Our Ref: 428.09985.00001

Your Ref: 20/00170/FUL

**RE: PLANNING APPLICATION 20/00170/FUL
PROPOSED GLASSHOUSE
GAVEL ROAD, KILSYTH
[CRAIGMARLOCH NURSERY EXTENSION]**

Figure 1 : Meadowside Catchment

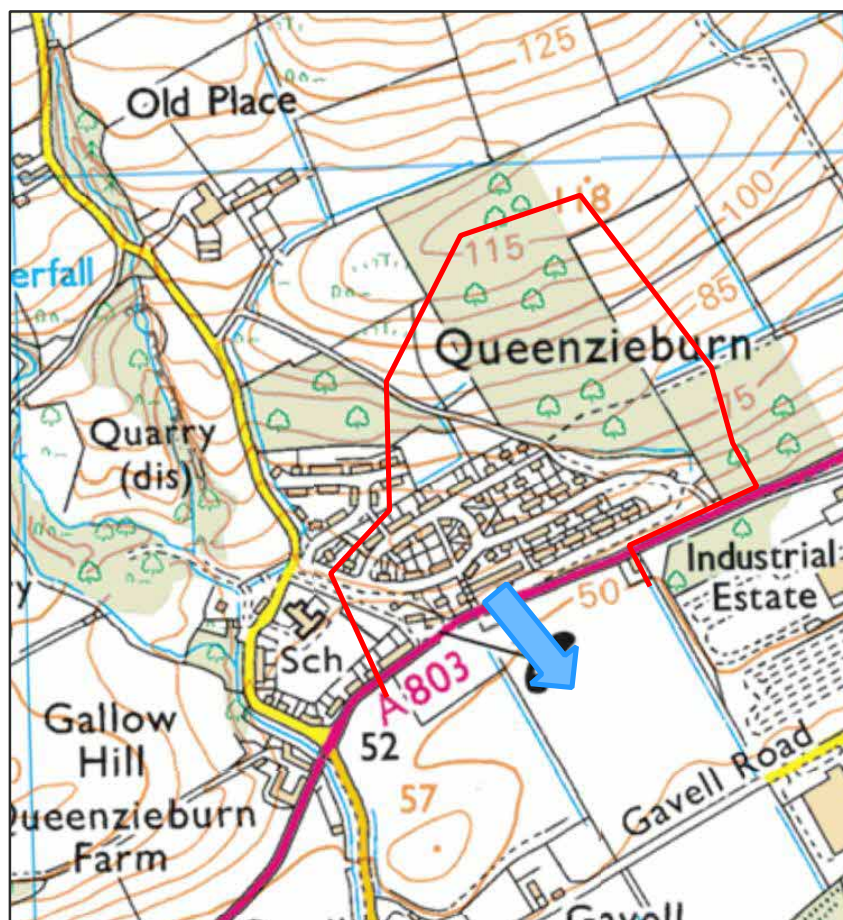
- 1.8 Based on the 200-year outputs (shown in Figure 7-3), it is evident that the site is at risk from flooding from the Queenzie Burn and also from flow from Meadowside Road catchment. As a result of the revised assessment, the model inflows highlighted within Figure 5-3 are more refined, where it is clear they are two separate inflows in the model. It was previously assumed that the Meadowside Inflow discharged into the Queenzie Burn. It is not clear why the Meadowside flow is discharged onto a playing field from the roadside. Further information should be provided on this outcome.

The FRA had advised that this is a small local catchment within the residential area of Queenzieburn village (around Meadowside Road) that drains towards the A803 and then potentially towards the site. The FRA notes that the catchment area is some 0.2km² (20ha), compared to 3.2km² for Queenzie Burn and 35.5km² for the River Kelvin. This catchment is some 6% of the size of the Queenzie Burn catchment.

The upper half of this catchment consists of fields, from where overland flow moves down-slope towards the lower (urbanised) half of the catchment, which is serviced by a piped drainage system. In extreme flood events such as the 1:200 AEP event, piped drainage systems would be unlikely to accommodate the runoff, and surface flow would occur. The shape of this catchment means that any such flow would be directed onto the A803, as shown in Figure 1 below.

There is a dip in the A803 between the east and western boundaries of this catchment, which means that flow would not move west (towards the Queenzie Burn) or east (towards the Industrial Estate), but rather be directed across the A803 and spill onto the fields.

That is the reason why this was modelled as a separate inflow point to the model. As a conservative position, it was assumed that there would be no loss of surface flow into piped systems, but rather that all the flow from this catchment is directed as surface flow into the study area.

Figure 2 : Present Day 1:200 Event – Run 50 - Inflow From Queenzie Burn Catchment

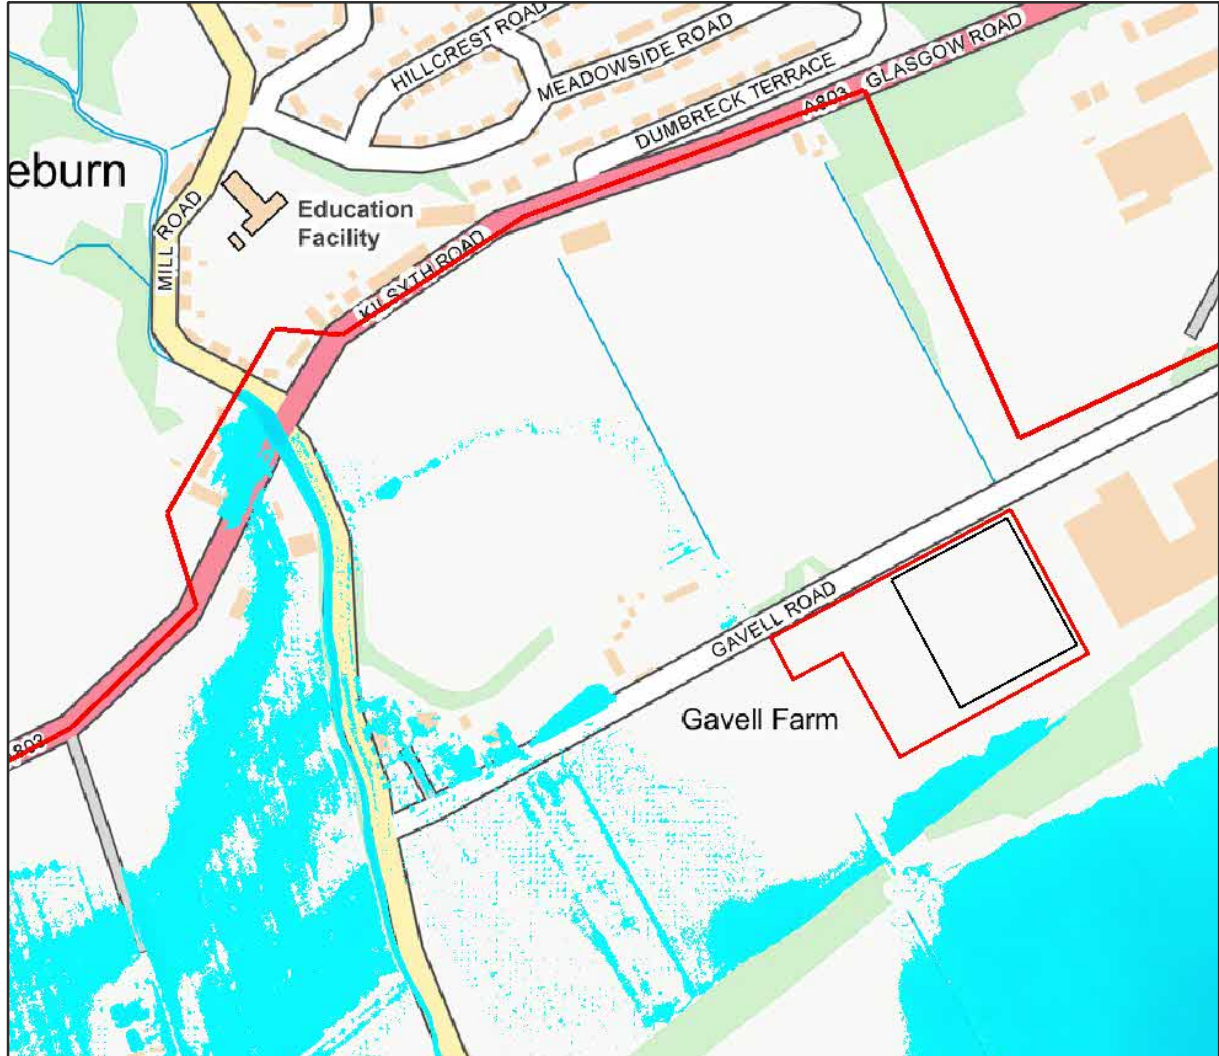
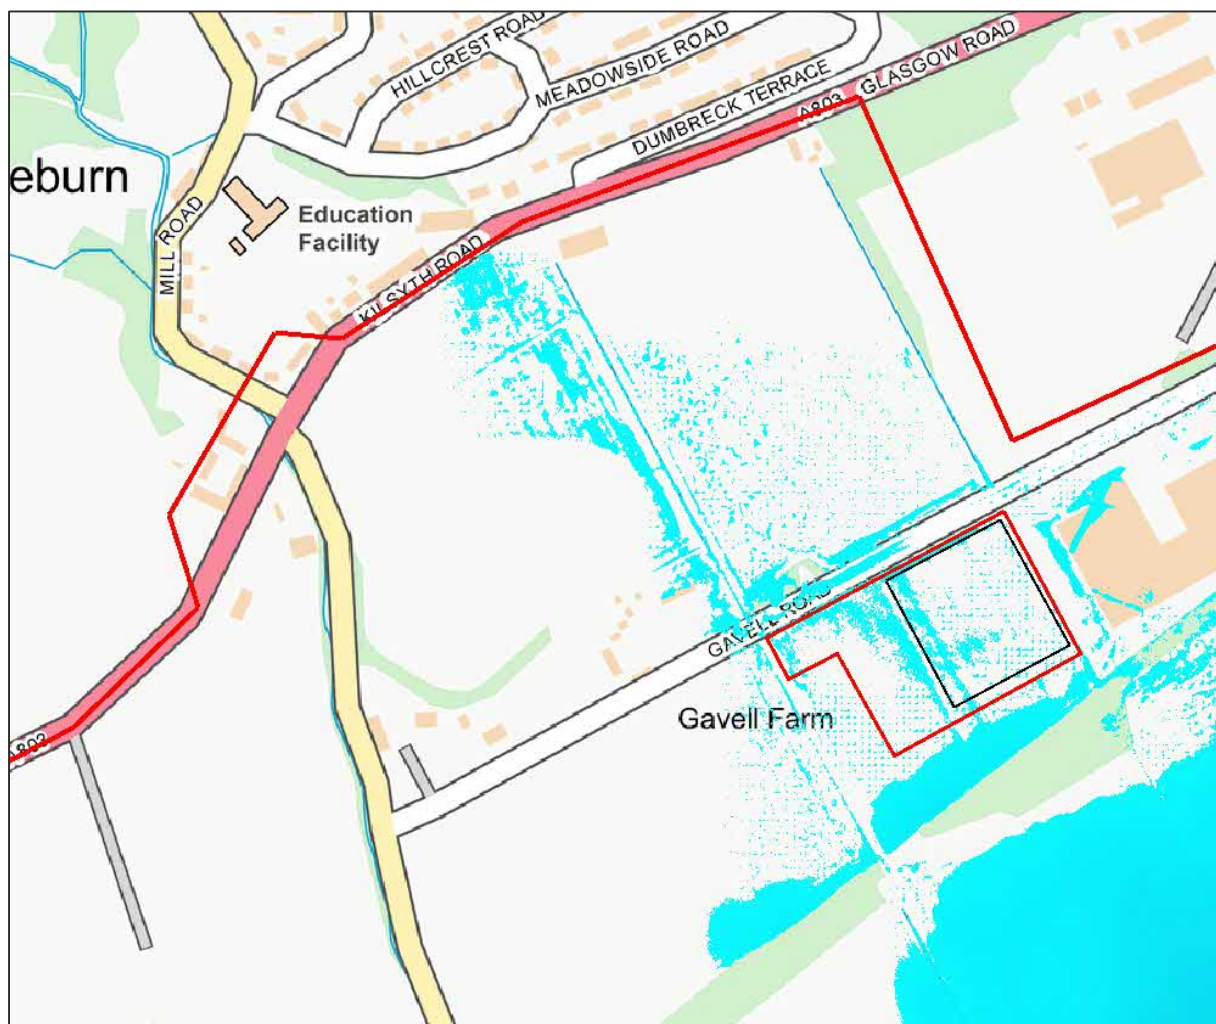
1.13 For the 200-year flood extents (Figure 7-3), there is a clear flow path through the middle of

the site. The FRA argues that this is not functional floodplain as the site is not adjacent to the watercourse and that the flows are surface water in nature. However, the flood waters originate from a fluvial source and are therefore considered to represent the functional floodplain, in line with SPP.

We have carried out two further model runs at the present day 1:200 AEP level, which illustrate the relative contributions to the flows occurring at and around the subject site. One run (see Figure 2) has inflow from Queenzie Burn (along with the River Kelvin) but no inflow from Meadowside catchment. The second run (Figure 3) has inflow from Meadowside Catchment (along with River Kelvin) but not from Queenzie Burn.

It is clear from Figure 2 that flows originating from Queenzie Burn do not impact on the application site itself or the proposed glasshouse building. The flow patterns that have been presented in the FRA are seen to be solely due to the contribution from surface water flows from the Meadowside Catchment.

Therefore, addressing the point made by SEPA in their paragraph 1.13 (the flood waters originate from a fluvial source and are therefore considered to represent the functional floodplain), the flows reaching this development site are seen not to be fluvial in origin; they are surface water flows.

On that basis, the site is not within the functional floodplain, and therefore there is no basis for an objection from SEPA.
